LAND USE DIVISION INTEROFFICE MEMORANDUM

RE: SUBDIVISION REQUIREMENTS - IN THE MATTER OF THE APPLICATION OF KRAMER PROPERTIES, APN 017-032-003, APPS 9902, FMS 15-004, PDP 15-001, GPA 15-005, AND ZR 15-008 FOR APPROVAL OF A TENTATIVE MAP, CONSISTING OF 81 ACRES INTO 156 LOTS

DATE: 12/27/2021
01/06/2022 Revised
03/14/2022 Revised (typographical error corrected)
02/15/2023 Revised per Board of Supervisors Meeting 3/22/2022

Above: diagram of proposed McKay Community Forest Trail

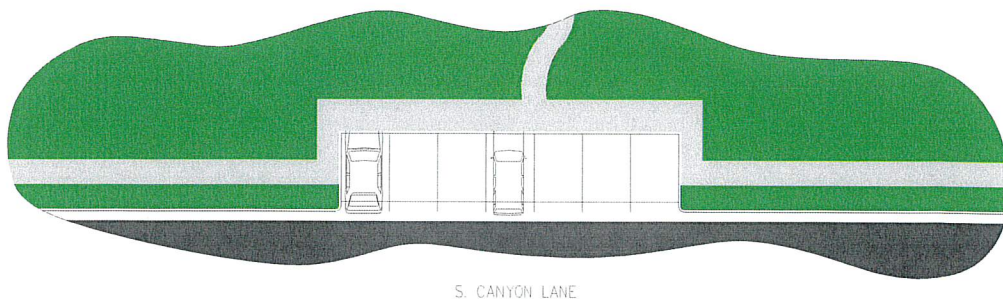
McKay Community Forest Trail: As part of the first phase, the Applicant shall cause to be dedicated to the County of Humboldt on the subdivision map a minimum 20 foot wide easement for public trail purposes over the McKay Community Forest trail that falls within the proposed subdivision as shown in the diagram below. This shall be dedicated in manner and location as approved by this Department.

Lot 52 Trail Connection: At that time that Lot 52 is developed applicant shall submit a trail connection plan to the County of Humboldt for review and approval. The plan shall show a connection from Arbutus Street and/or Oakview Drive to the McKay Community Forest Trail. The applicant shall construct the trail connection as part of the development of Lot 52 and shall dedicate to the County of Humboldt a 20 foot wide easement for public trail/sidewalk purposes. This shall be dedicated in manner and location as approved by this Department.

Lot 20 Trail Connection: The applicant shall dedicate to the County of Humboldt a 20 foot wide easement for public trail/sidewalk purposes between Lots 19 and 20 to connect Oakview Drive with the McKay Community Forest Trail.

Lots 44/45 Trail Connection: The applicant shall dedicate to the County of Humboldt a 20 foot wide easement for public trail/sidewalk purposes between Lots 44 and 45 to connect Oakview Drive with the McKay Community Forest Trail.

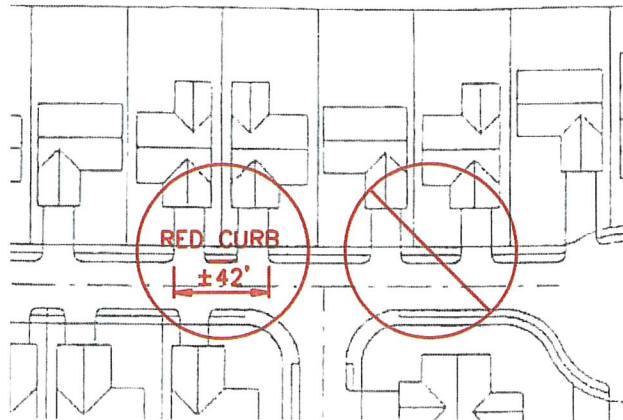
Wherever feasible, driveways shall be placed back-to-back to provide ± 42 foot long "turnouts" for standard two-car wide (18 foot wide) driveways. [± 26 foot long "turnouts" are provided with one-car (10 foot wide) driveways]. See the diagram below: The circle on the left represents the ideal condition with back-to-back driveways; the circle on the right represents the condition that should be avoided.

STANDARD PARKING STALL WITH WHEEL STOP

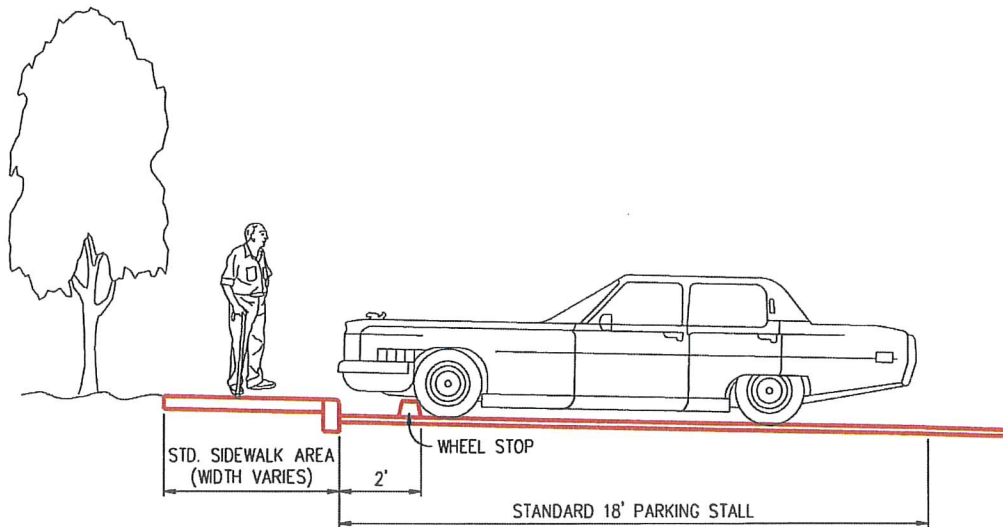
Parking stalls are typically 8 feet wide x 18 feet long. When sidewalk is placed in front of a parking stall, wheel stop blocks are required. In lieu of wheel stop blocks, the length of the parking stall may be reduced by 2 feet and the width of the sidewalk increased by 2 feet so that the curb acts as a wheel stop.

Above: Cross section for trails within the McKay Community Forest

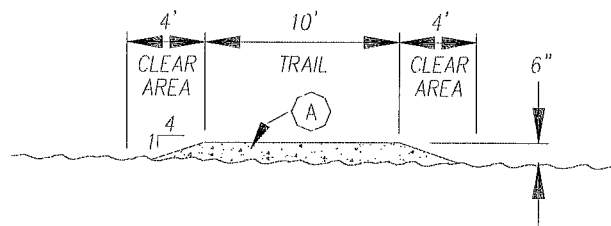
- A= 6" of compacted crusher fines (or other materials suitable approved by the Department for temporary installation)
